City of Jurupa Valley 2021 Complete Streets Safety Assessment (CSSA)

Observations and Suggestions

November 18, 2021

Engineering Evaluator UC Berkeley SafeTREC

Agate Street - Suggestions

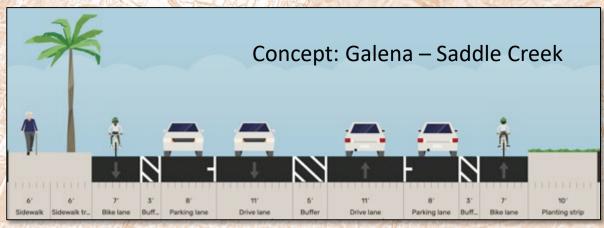
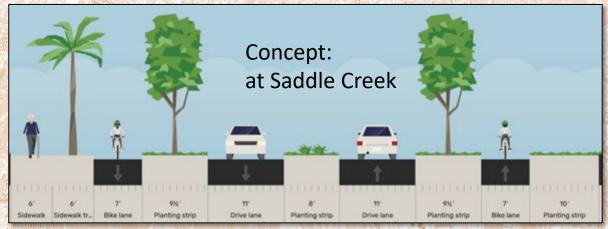
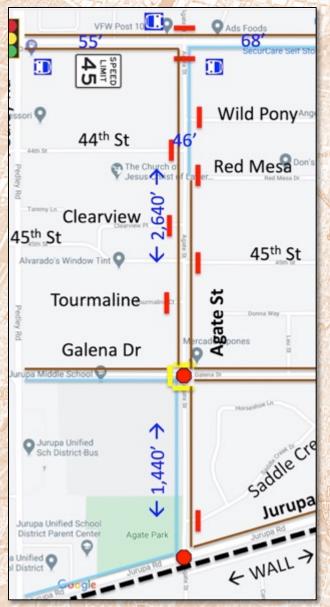
| # | Location | Item | Suggestion | | | | | |
|---|--|--|---|--|--|--|--|--|
| 1 | Mission Boulevard | Facilitating pedestrian crossings | a) With current uncontrolled approaches, consider 11' traffic lanes, 10' left turn lane, and 7' bike lanes away from the intersection. At intersection, transition to 5' bike lanes to fit 4' stinger islands along turn lanes, providing some protection for pedestrians halfway across. | | | | | |
| | | | b) Ultimately, signalize the intersection | | | | | |
| | | Short term: | a) Develop "spot" solutions where the unpaved frontage is not wide enough for a walkway along parallel parking. | | | | | |
| 2 | | walkway continuity along unpaved frontage b) At all locations, prohibit perpendicular regulatory signs ("Park Parallel"), with our benefits of a continuous walking area for c) Consider speed feedback signs and speed | | | | | | |
| 4 | | Traffic calming and safer, more convenient pedestrian crossings | Add physical deflection such as mini-roundabouts and/or speed humps, spaced closely enough to be effective — at least at the "1/3 points" where there are through routes between Pedley and Vernon: a) Between 44th Street and Red Mesa Drive b) At 45th Street | | | | | |
| 5 | Alley on east side south of Red Mesa Drive | North fence of south-side property blocks sight triangle | Have the owner reduce the first segment's height to lower- than-driver's-eye, or replace it with a see-through treatment. Alternatively, install islands beyond the north-south fence line to protect motorists who creep out to get a clear sightline. | | | | | |
| 6 | Galena Street intersection | Traffic control, pedestrian safety | Consider installing a single-lane roundabout. See discussion above, in the "Galena Street intersection" section. | | | | | |
| 7 | Between Galena and Jurupa Road | Bicycle accommodation | Consider parking-separated bike lanes (see Figure 4-11). | | | | | |
| 8 | Saddle Creek Drive intersection | Enhanced crosswalk | Mark and sign a high-visibility crosswalk on the north leg, with islands "capping" the floating parking lanes to the north, and a wide median island to protect persons walking bicycles. Use double-sided signs to maximize motorist awareness. | | | | | |
| 9 | Jurupa Road intersection | Crosswalks | Install advance limit (stop) lines 4' before the marked crosswalks on the southbound and eastbound approaches. | | | | | |

34th Street (Roubidoux - Crestmore)

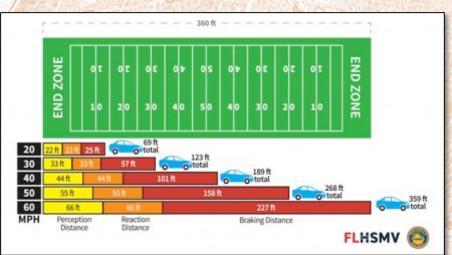
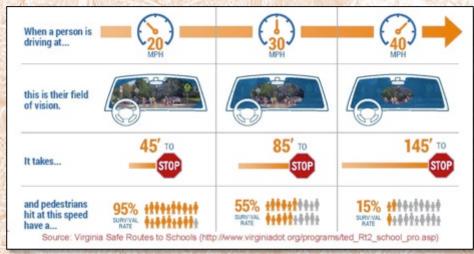
| MAIL | # | Location | Item | Suggestion |
|---|---|--|--|---|
| たる 一人 | 1 | 34th Street roadway | Reducing speed to 25 | a) Consider installing traffic calming devices at the one-third points between Roubidoux and Wallace: * East side of Mt. Calvary church (~600' from Wallace) * Near Torre Fuerte Roubidoux (~600 from Roubidoux) Devices could potentially be speed humps, "speed cushions" (slotted speed humps), or one-way slow points. |
| | | Toddway | mph range | b) Consider installing a traffic calming device within or adjacent the Daly Avenue intersection (~700' from both Wallace and Crestmore), such as a speed hump on the east or west leg, or a neighborhood traffic circle — possibly with small deflection islands to prevent "bypassing". |
| # E | 2 | 34th Street – walkway | Need for assured width given parking along shoulders | Require that all on-street parking use the north shoulder. On the south side between the pavement edge and front yard fence lines, install a standard sidewalk or a walkway protected from traffic with a raised feature such as an intermittent asphalt dike. |
| | 3 | School pedestrian access from Arora / 35th | Need for all- weather walkway | Add a minimum 8' paved walkway between Arora Street's school crosswalk at 35th Street, and the school's northeast pedestrian gate approximately 160' west. |
| ley la | 4 | Walkway between 34th and 35th along east edge of Mt. Calvary church yard | Need to preserve access in perpetuity | a) Obtain an access easement, or b) Purchase a strip of land along the fence |
| 1 | 5 | 34th Street and other low-volume rural roadways | Alternative cross section | Look into Edge Lane Roads for potential applicability in Jurupa Valley. |

| # | Location | Item | Suggestion |

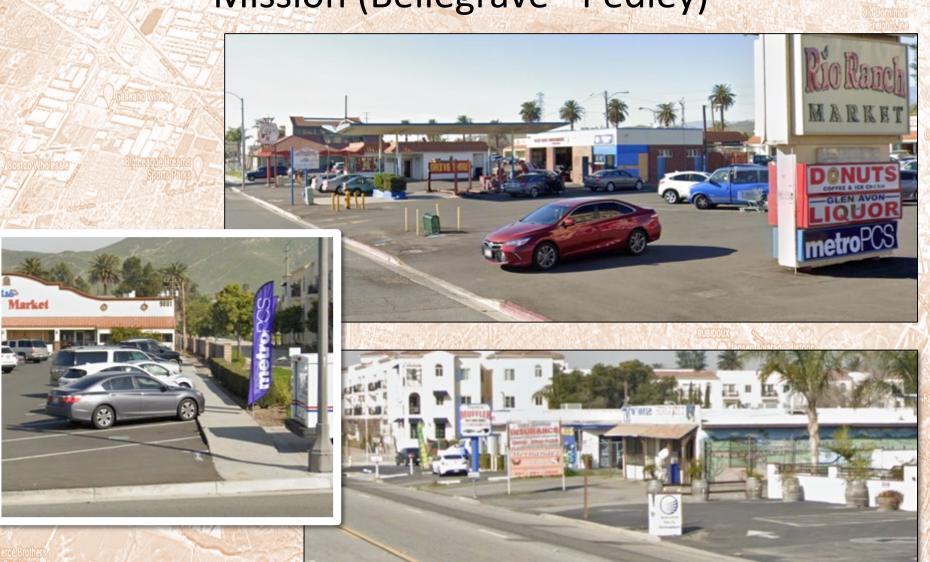
| # | Location | Item | Suggestion |
|---|---|--|--|
| | | | Create a segmented sidewalk improvement plan — see Table 4-12. Prioritize and phase implementation. |
| 1 | Entire focal area | Sidewalk connectivity | Along each segment, ensure that the walking route has gently sloped bypasses at each driveway apron, minimize or eliminate perpendicular parking, and ensure that the walking route is protected from vehicle circulation and parking movements, and buffered from the door-opening area beside parked vehicles. |
| 2 | Crossing at Amarillo | Need for active device | Consider installing an enhanced crosswalk with pedestrian- activated active features — either Rectangular Rapid Flashing Beacons (RRFBs) or a Pedestrian Hybrid Beacon (PHB). |
| 3 | Back-side pedestrian access to Rio Ranch | Vegetation blocks sightlines | Remove or replace tall bushes |
| 4 | Market shopping plaza, on Bellegrave | Adjacent sidewalk | Extend to the pedestrian access point |
| 5 | New developments including residential subdivisions | Pedestrian shortcuts and related connectivity | In the City's Municipal Codes, subdivision design guide, and planning review, require developments to provide fine-grained pedestrian / bicycle connectivity including shortcuts at culs-desac and periodically along long blocks, and connections to collector and arterial streets and nearby trails. See Figure 4-37 and associated discussion. |
